GAU-19 GEAR COVER

*Upgraded replacement for the legacy feeder gear cover
PN: 10086883*

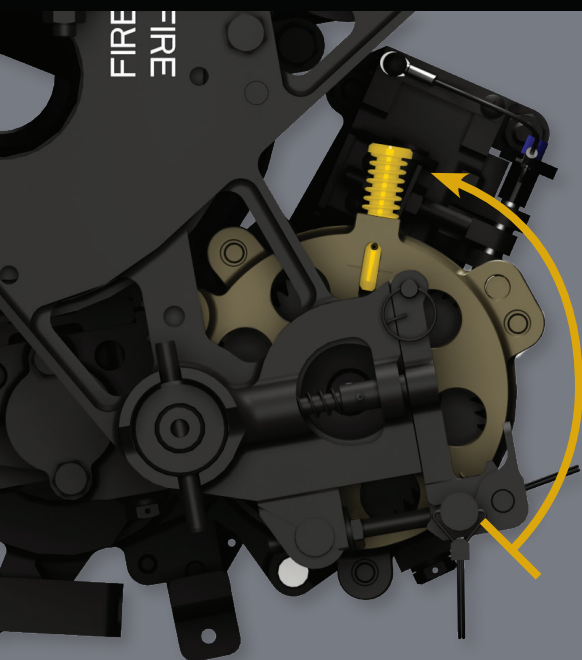
Timing pin is rotated up 45° which reduces overall package size and places it in a more protected area

Installed using the same hardware as the legacy gear cover (3x bolts)

Corrects a 4° timing error in the legacy part, eliminating a timing pin sticking point

Improved ergonomics to install the gear cover onto the powered delinker—no “third hand” necessary!
